PCN – Process Change Notification

Change:	OMB.433.B03F21
Date:	2018/04/20
Author	Bonnie Chen

Model#	Part Number	Changes
433MHz 3dBi Omni Antenna, with N Type Female Connector, U-Bolt, 523mm Length Ø70*55mm	OMB.433.B03F21	1. Change bracket from 4 holes to 2 holes.

Illustration of Change

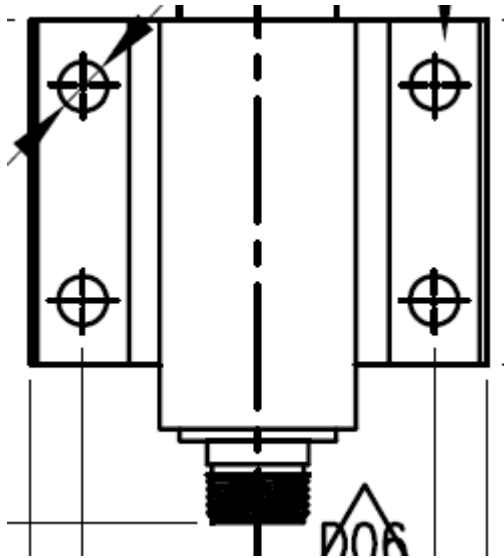
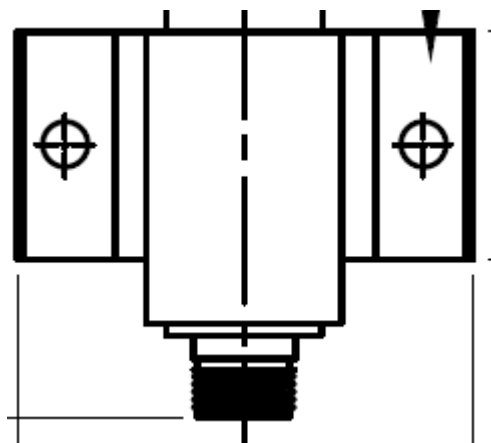
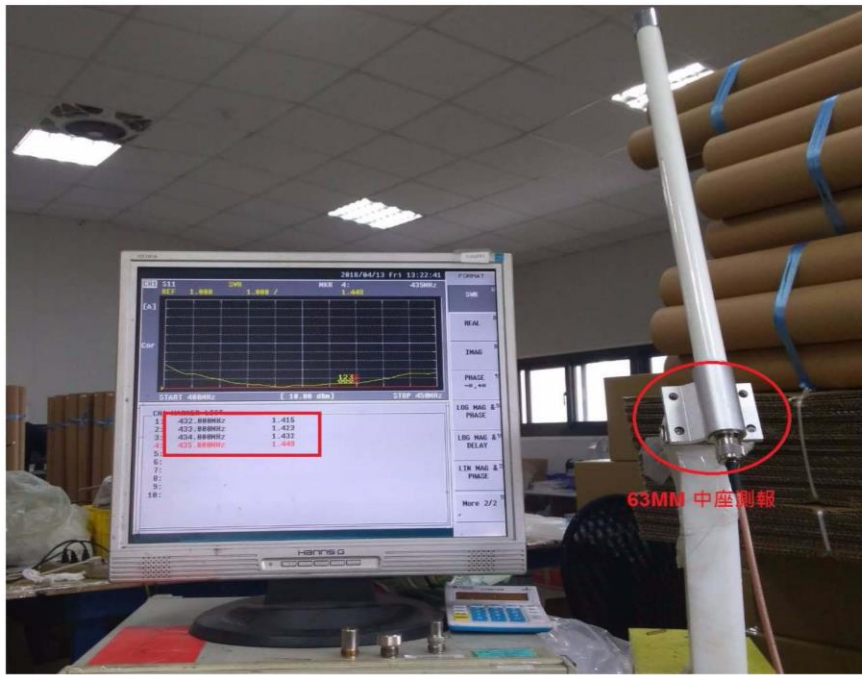
- Hardware Modification
 Production Process Advance
 Others –Change bracket from 4 holes to 2 holes.
-

Taoglas tested the VSWR data, we found two holes data is better than four holes. So we had been changed the bracket to get better performance.
